PART TWENTY
PROJECT EVOLUTION

Design Response to Previous DRP and Council Comments

CALDYNE PARK

Land at Caldine Park,
Turners Hill Rd,
West Sussex
RH10 4NB

Scheme 2 - Massing Concept Evolution

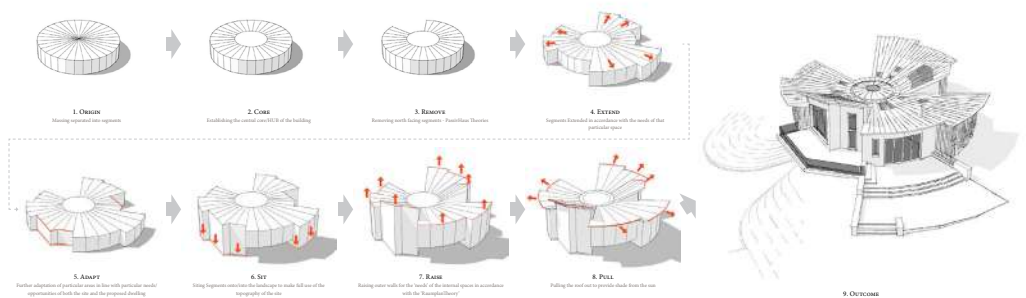
B - ‘The panel agreed that the concentric circles idea was an interesting concept. Unfortunately, it had not been followed through thoroughly. It would greatly benefit from developing on many levels including materials, layout, sustainability and ecology.’

As a consequence of this review the scheme was extensively redesigned on many levels, with the concept extensively developed into the proposal at multiple layers.

Initially, the concept was evaluated and critically developed to inform the interior layout alongside the 3 Dimensional form. Then, the concept was advanced to inform multiple layers, such as massing, orientation, materials, ecology, sustainability, landscaping and low-carbon strategies. See parts 10 - 19 of this supporting document for further information.

The new scheme has advanced from this core concept, which originates from the cross section of a tree trunk (i.e. 3D form). From this concept The Dwelling formed from a series of varying sections around a central core (The Heart of The House). These sections then form a series of sectional spaces of purposeful length and height, which have been determined by key site features and internal room requirements.

In addition to this, the evolution of the massing concept started from a central core (aligned with the layout) within variously positioned and lengthened segments to satisfy key site features and internal room requirements. The massing segments were merged into the existing topography whilst also being raised to optimise both solar gain and views. Critically, two segmented areas have been adapted to signify the entrances and provide the principal strategic view through the dwelling into the west meadow and over the woodland tree line.

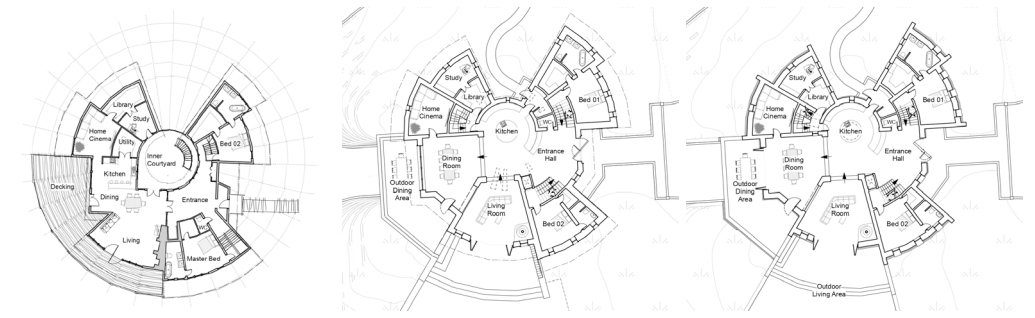
B - ‘The building seems to sit on the landscape rather than within it and suggested a randomly landed lunar craft... The raised deck idea leads to a dead ground floor elevation with a dark undercroft that results in an uninviting building... The raised platform also makes the building seem remote from its surrounds. The building is not high enough to be above the trees to enjoy uninterrupted views with the added inconvenience of being raised above the ground via excessive stepped accesses. It would benefit from being brought down to ground level where it can better engage the surrounding landscape with the garage placed elsewhere.’

On reflection, we agreed with these comments and redesigned the proposal to merge with the natural level change of the landscape. The ‘lunar craft’ landed on the ground level, with a stone base anchoring the building to the site. A lightweight timber structure sits above, blending into the surrounding landscape (Scheme 2 & 3). On approach to the dwelling’s main entrance is a level entrance with a large striking pivot door, enabling the outside to penetrate the interior space seamlessly. On entry into the house, one is greeted to a large, spacious, high-ceilinged entrance hall, where one is then led towards the core of the building (kitchen), with spectacular 360°-framed views into the surrounding woodland. These views are possible through the dwelling’s exceptional utilisation of the site’s existing topographical level changes. The internal and external spaces are uniquely interconnected and arranged by embracing these level changes - Raumplan Theory.

The proposal has been carefully designed to utilise the natural level changes of the site, forming a dwelling that is nestled into the existing topography. The dwelling is anchored to the landscape through a locally sourced stone base and a lightweight vertical timber cladding above echoing the surrounding woodland. The dwellings unique frontage and positioning within the ground forms a harmonious threshold between the dwelling and landscape.

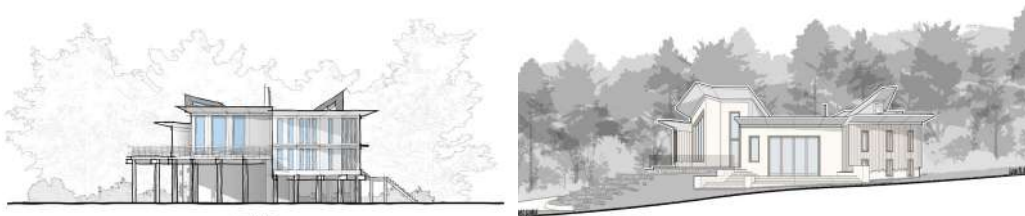
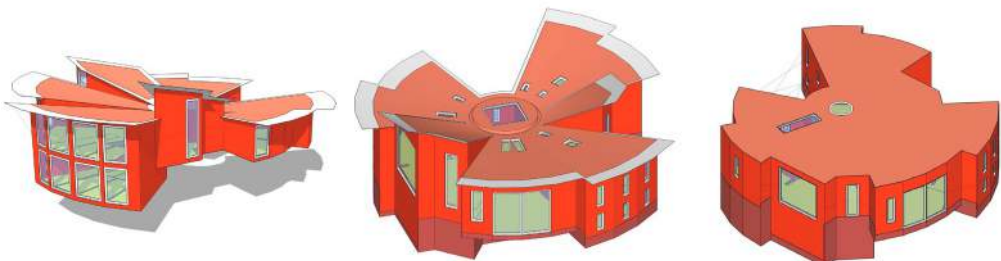
B - ‘The drawings need to show the relationship between the different materials more clearly.’

E - ‘The circular plan is handled as a series of faceted facades, rather than curved ones according to the floorplan but this is not revealed in the elevations which look flat.’

E - ‘Insufficient information/drawings are provided to show the relationship of the building with its context and immediate threshold. The floorplans don’t show them, the scale of the site plan is too small, and the elevations show the surrounds too schematically.’

On reflection, we agree that the original drawings submitted did not clearly show the relationship between the materials (Sketched). Therefore, to amend this, we developed a new drawing strategy that clearly shows materials and spatial qualities. Additionally, we added a series of new drawings (such as 1:20 detail sections and exploded axonometrics) and renderings that clearly show the relationships between the different materials.

As part of the new drawing strategy, the floor plans were amended to show the building’s rectilinear structure clearly. However, in elevation, the building’s rectilinear elements are obscured by the dry-laid stonework and vertical timber cladding, which give the building the illusion of a curved facade. The proposal has been meticulously designed to ensure the harmony of the concentric concept is also embodied in the external form.

On reflection, we agreed with this and amended the drawings to clearly show the surrounding context, and the plan scales have been doubled to show further information. In addition, for a detailed understanding of the proposal’s relationship with its context and how it sits elegantly within its immediate threshold, see parts 12 and 13 of this statement. Critically for the new scheme, a series of contextual visualisations have also been created that clearly show the building within its setting - Part 14.

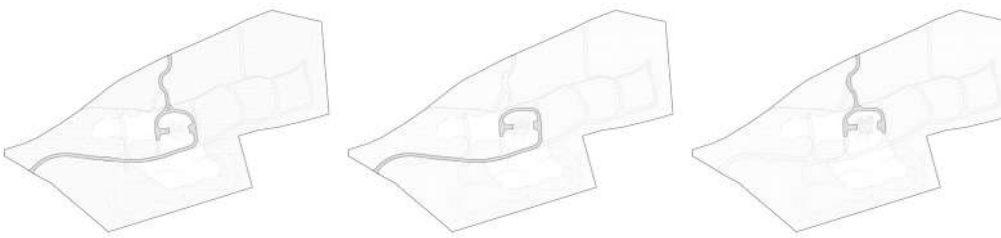
B - ‘The scheme’s Passivhaus credentials were questioned because of the complexity of the design, thermal bridging issues and the need for much thicker walls to meet the standard.’

E - ‘Also if the building is aiming for passivhaus standards, this needs to be demonstrated (and it may be undermined by its relatively high surface area to volume ratio resulting from the series of recesses and projections and its predominantly single storey form).’

Sitting the scheme into the ground significantly reduced the complexity of the design. In addition, the Scheme 02 and The Final Scheme 03 have also undergone extensive Passivhaus analysis, critically including DesignPH Software, which ensures the design meets Passivhaus standards. See part 15 of this supporting document for further information.

The final design has been analysed using Design PH, which ensures the design meets the passivhaus requirements. This has been demonstrated in Part 15 of the supporting document. In addition, surface-area-to-volume ratio (S/V) is an inaccurate and ineffective indicator of a buildings thermal behaviour as it does not account for many important variables, such as environmental factors and the building envelope (see part 15 for a more detailed explanation).

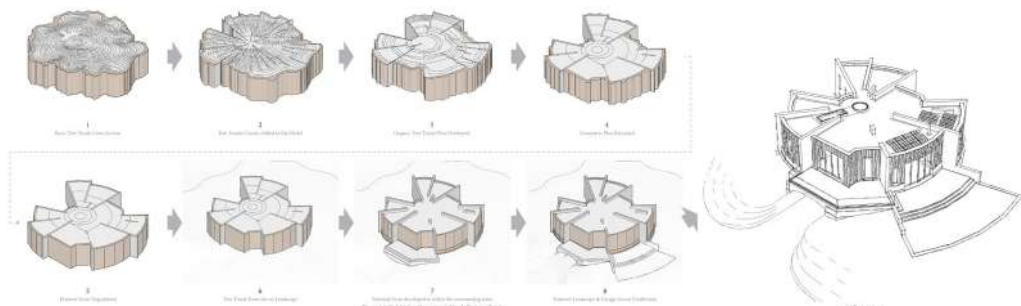
H - ‘There is limited information in the presentation demonstrating how the site would be enhanced. Whilst the proposal to remove invasive rhododendron is welcome, it is unclear how this would be achieved, over what period and the replanting proposals.’

The information regarding rhododendron removal and woodland management is clearly shown in Part 19 (paragraphs 4.0 - 4.27) of The Supporting Documents. Additional information on the rhododendron removal is also presented in parts 8, 9, and 18 of The Supporting Documents.
